Photo Album History of the Ashville Park

Exhibit E Continued

November 5, 2021

Current Playground Conditions

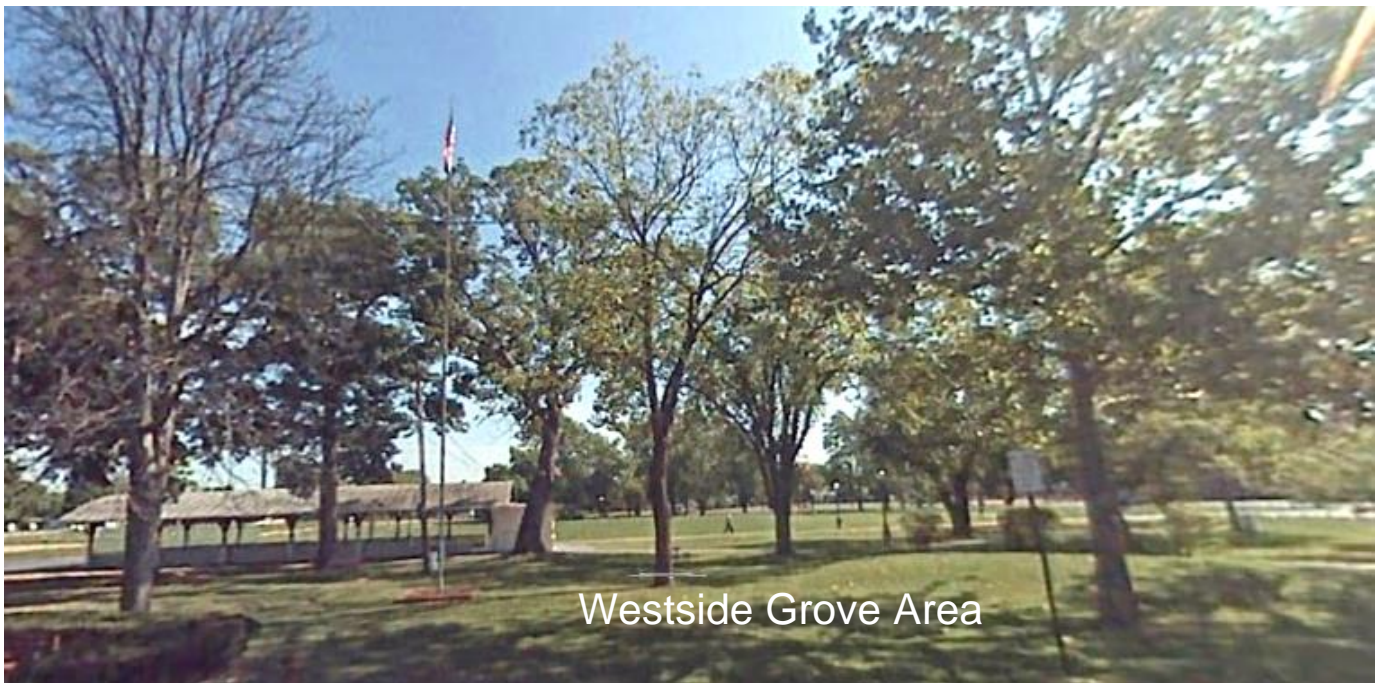
Surfacing is too thin (lacking proper depth). Concrete footers are exposed.

This sectional slide has gaps present that are non-compliant with ASTM F1487-17 6.4.1.2 6.4.1.2 Slides shall be constructed in such a manner as to provide a continuous sliding surface (roller slides exempted) and shall minimize the likelihood of entanglements.

This section of the slide is broken and should be replaced.
